Official Journal

COMMISSION DIRECTIVE

adapting to technical progress Council Directive 77/541/EEC on the approximation of the laws of the Member States relating to safety belts and restraint systems of motor vehicles

(90/628/EEC)

Figure 1

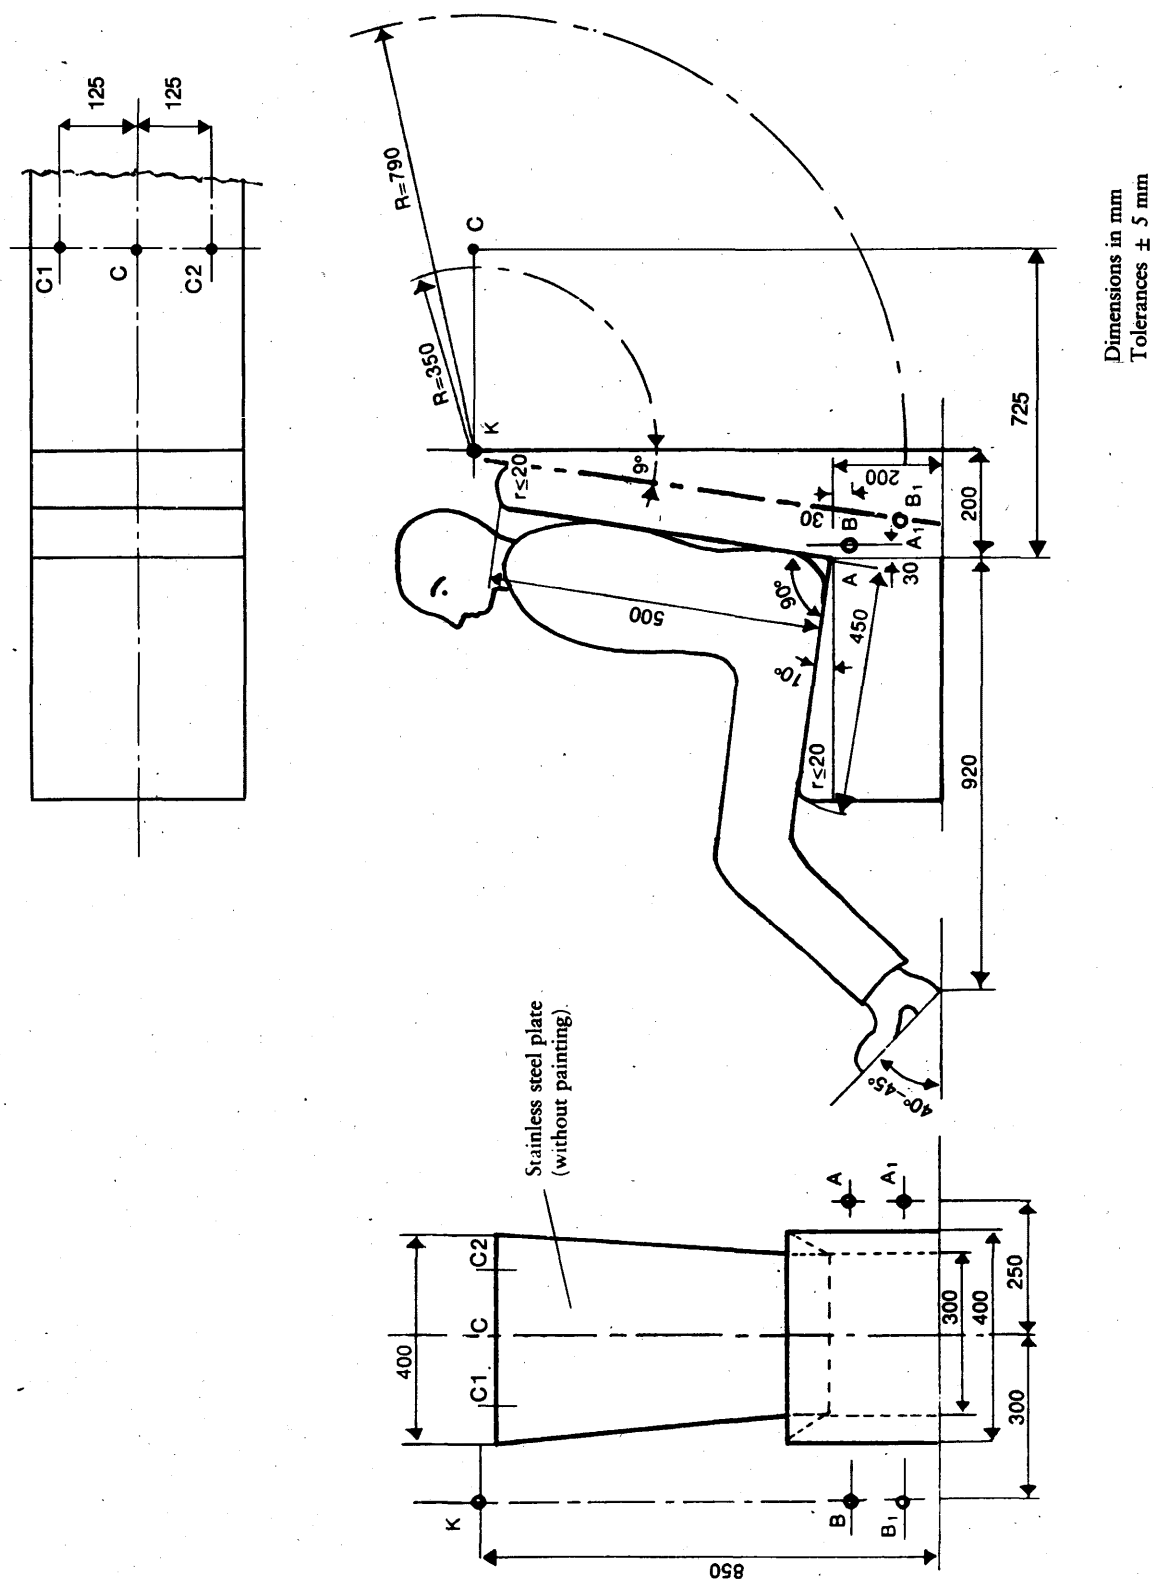
‘The tolerance on the position of the anchorage points is such that each anchorage point shall be situated at most at 50 mm from corresponding A, B and K indicated in figure 1, or A1, B1 and K, as the case may be.’

‘3.1. In the case of a belt equipped with a belt adjustment device for height as defined in 1.8.6 of this Directive, this device shall be secured either to a rigid frame, or to a part of the vehicle on which it is normally mounted which shall be securely fixed on the test trolley.’

Figure 1 is replaced by the following figure:
